Subject: MW LP to MW2 LP Upgrade

We are pleased to inform you about a major technical upgrade that will benefit all MW LP pumps (45 mm, 50 mm and 55 mm plungers). Our design team has made modifications to the manifold, thickness of the inlet valve cover, length of the valve cover bolts and last, changing the valve cover O-ring seal diameter. This change has been made effective immediately and the pumps have been renamed MW2 LP.

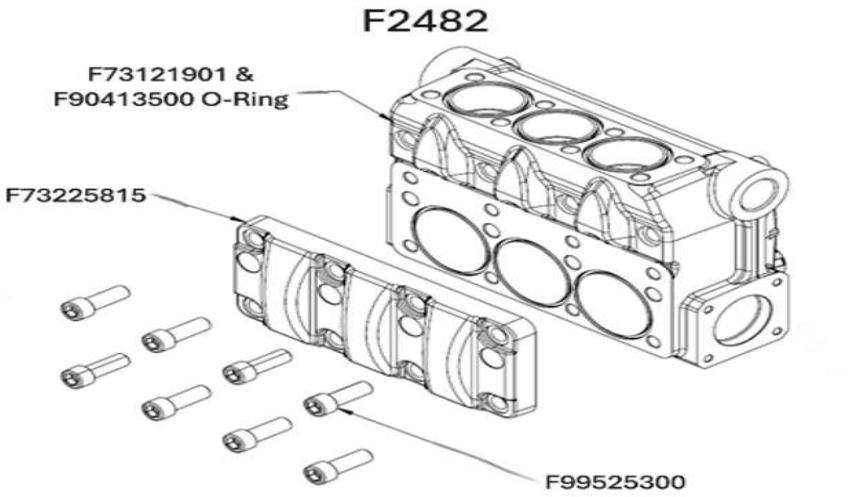
The upgrade affects the following manifold components, which have been strengthened to better withstand even the most demanding working conditions up to 100 HP.

Manifold -F73121601 – New PN F73121901

Inlet Valve Plate Cover - F73225615 – New PN F73225815

O-ring Seal - F90414200 Dia. 85.32 x 3.53 - New PN F90413500 Dia. 75.8 x 3.53 (Qty 3 Required)

Bolts - Old PN F99525000 M18 x 50 mm - New PN F99525300 M18 x 65 mm (Torque 490 Nm) (Qty 8 Required)

The manifold and inlet valve cover are interchangeable with the previous version. Furthermore, overall dimensions, internal components and spare parts and kits along with all other assembly specifications remain unchanged.
